**Marion County
Board of County Commissioners**

**PLANNING & ZONING SECTION
STAFF REPORT**

| Case Number: | 250802SU | |
| Type of Case: | Special Use Permit: Outdoor storage of RVs, boats, trailers, and any ancillary use for vehicle storage | |

Figure 8

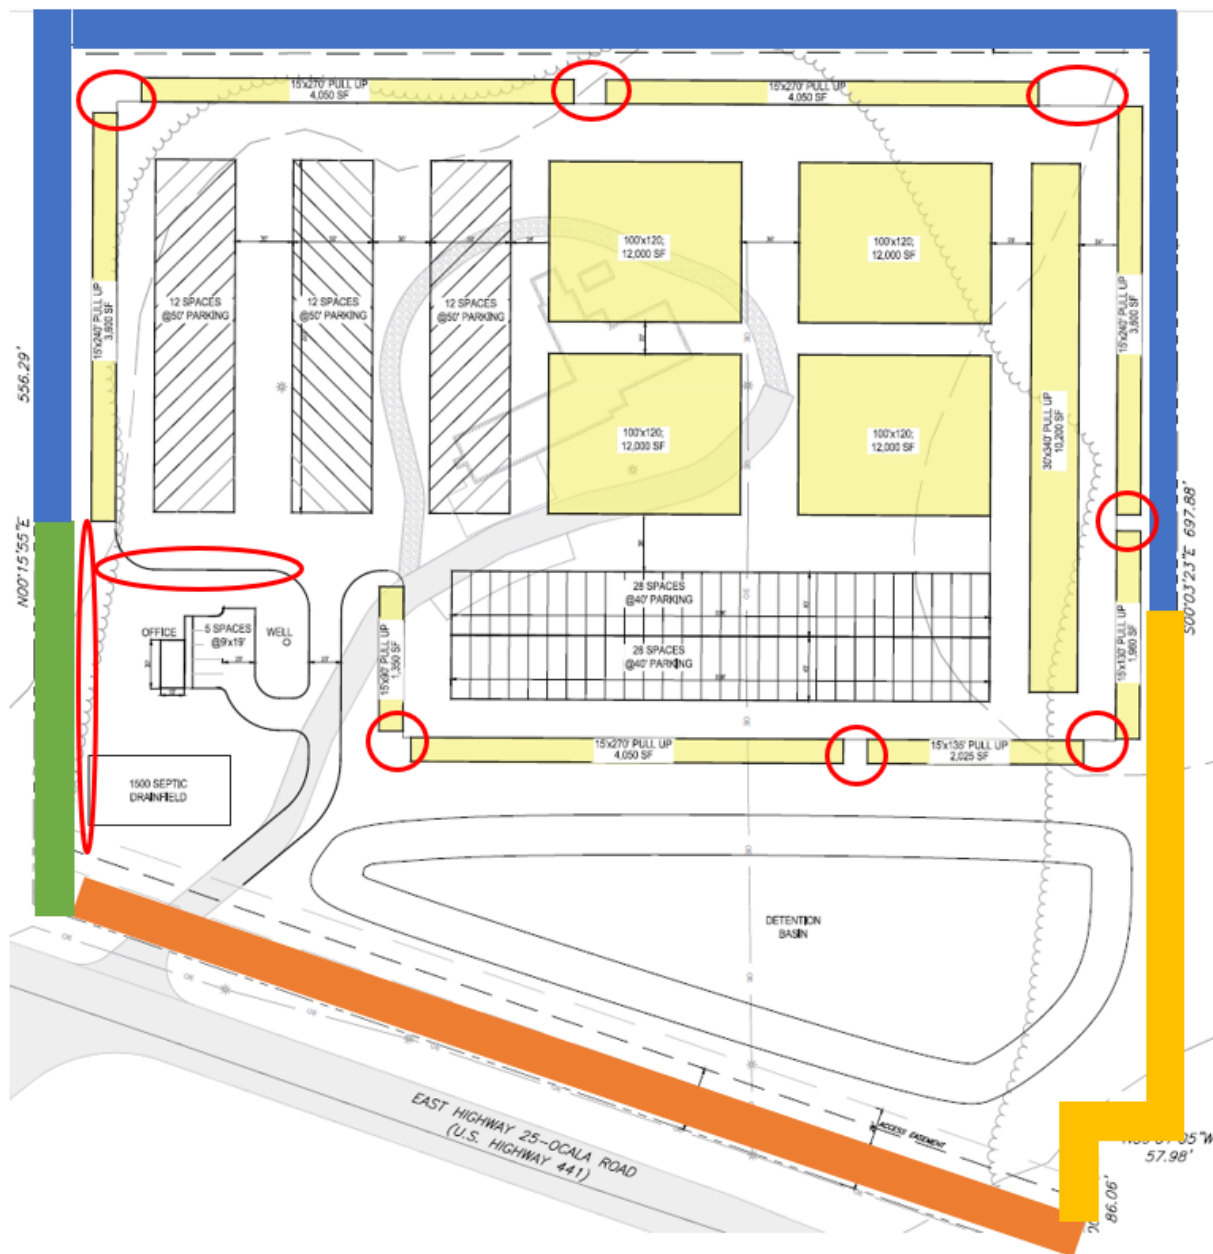
Regarding buffering, the conceptual plan shows a 20-foot Type B buffer along the west and north property boundaries which host residential uses. A 20-foot Type B buffer is consistent with LDC requirements. If the back-side of the pull-up storage walls facing the adjacent properties do not have windows, staff supports using the building walls to satisfy the Type B buffer wall requirement. In the event there are gaps between the building walls, an opaque vinyl privacy fencing, at least 6-feet in height, shall also be provided in the gaps areas to create the effect of a continuous buffer wall and screen.

The Conceptual Plan calls out a 10-foot Type D buffer along the eastern property boundary, presumably based on the adjacent property's General Agriculture (A-1) zoning. When there is an existing use, buffers are based on the existing use instead of zoning. One of the adjacent eastern parcels is classified as multi-family residential and the other parcel is classified as utility, see Figure 4. Therefore, based on LDC Sec. 6.8.6.K, a combination of a 20-foot Type B buffer along the residential use and 15-foot Type C buffer are required along the public (utility) use. In the conditions below, staff proposes an alternative buffer to use existing trees for the eastern property boundary.

The conceptual plan does not indicate the required Type C buffer along the E Hwy 25 right-of-way and does not indicate a buffer along a portion of the Duke Energy Center property. These omitted buffers are addressed in Staff's conditions below.

Figure 8 provides a visual of where these buffers would be located based on the Conceptual Plan.

Regarding screens, the Conceptual Plan (dated March 2025) does not indicate that a continuous eight (8) foot tall opaque screen – as required by the LDC – will surround the parking areas. If the pull-up storage units facing adjacent properties and streets do not have windows and they are at least 8' tall, then the storage unit walls can be used as screening. However, Figure 8 shows where there are gaps in the screening. Growth Services expects those gaps to be addressed during development review by providing a continuous storage unit wall or supplementing the gaps with an opaque vinyl privacy fencing, at least 6-feet in height. Staff supports reducing the typical height requirement of an 8-foot screen down to a 6-foot screen, contingent on preserving and using existing vegetation for the site's buffers.

- The outdoor vehicle storage parking spaces shall be located internal to the site and screened by pull-up / self-storage buildings, consistent with the Concept Plan (Dated 03/2025). The vehicle storage area clusters may be covered as elected by the applicant/owner/developer.

- In the event that gaps between pull-up / mini-storage buildings are provided to comply with Building/Fire Code requirements, the gaps between the buildings shall be filled with an opaque vinyl privacy fence reaching at least 6-feet in height. The opaque fencing combined with the buildings shall form a continuous screen blocking views from adjacent properties and E Hwy 25.

- Landscape area buffers shall be provided and maintained along the site's boundaries consistent with the following:
 - North, East, and West, where pull-up / self-storage buildings are located and abut existing residential properties – a modified 20' B-Type no-touch buffer. The blank rear-wall of the storage building(s) and fencing outlined in condition 3.a shall serve as the required buffer wall. The storage buildings and fences shall be located on the perimeter of the development area with the outdoor storage being internal to the storage buildings. Viable existing buffer vegetation, as confirmed by a Landscape Architect or Certified Arborist, shall be left in place and each viable tree's Critical Root Zone shall be adequately protected during site grading and development. Any gaps in existing buffer vegetation that do not meet B-Type buffer LDC requirements shall be planted per code.

- West, where pull-up / self-storage buildings are not located and where there is an adjacent existing residential property – a modified 20' B-type no-touch buffer. There shall be an opaque vinyl privacy fence reaching at least 6-feet in height running parallel with the preserved trees. Viable existing buffer vegetation, as confirmed by a Landscape Architect or Certified Arborist, shall be left in place and each viable tree's Critical Root Zone shall be adequately protected during site grading and development. Any gaps in existing buffer vegetation that do not meet B-Type buffer LDC requirements shall be planted per code.

- East, where pull-up / self-storage buildings are not located and where there is an adjacent public use – a 20' no-touch buffer. Viable existing buffer vegetation, as confirmed by a Landscape Architect or Certified Arborist, shall be left in place and each viable tree's Critical Root Zone shall be adequately protected during site grading and development. Any gaps in existing buffer vegetation shall be planted and maintained according to the LDC.

- South, along E Hwy 25 – a 15' C-Type buffer, per LDC requirements.
- No trees shall be removed from the property prior to obtaining Development Review Committee site plan approval.
